# DETENTION BASIN OUTLET STRUCTURE DESIGN

Project: Winsome Filing 3

Basin ID: H5B (INSTALLED DURING EARLY GRADING PHASE)

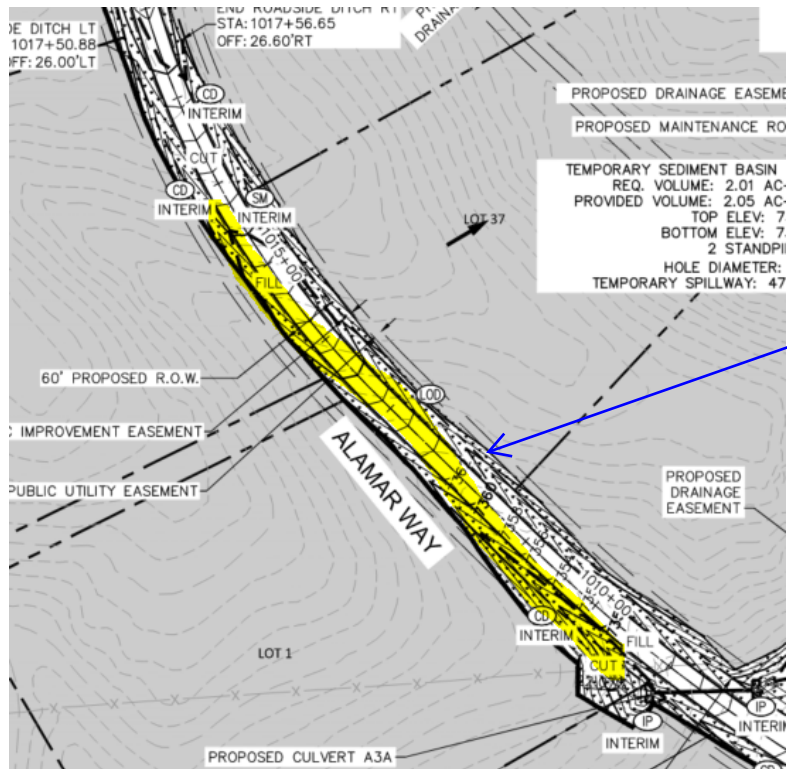
drain time should be at or near 72hrs for a sediment basin

Unresolved. See snippet above for MHFD DCM vol 3 criteria regarding sediment basin drain time.

Additionally update the GEC plan to provide either a trash rack or packed gravel in front of the orifice. Unclear what on the current design will prevent the orifice holes from being blocked/clogged as sediment builds up.

**KHA RESPONSE:**  
DESIGN HAS BEEN UPDATED TO SHOW WQCV BEING MET AND A TRASH RACK HAS BEEN PROVIDED TO PREVENT THE ORIFICE HOLES FROM BEING BLOCKED/CLOGGED.
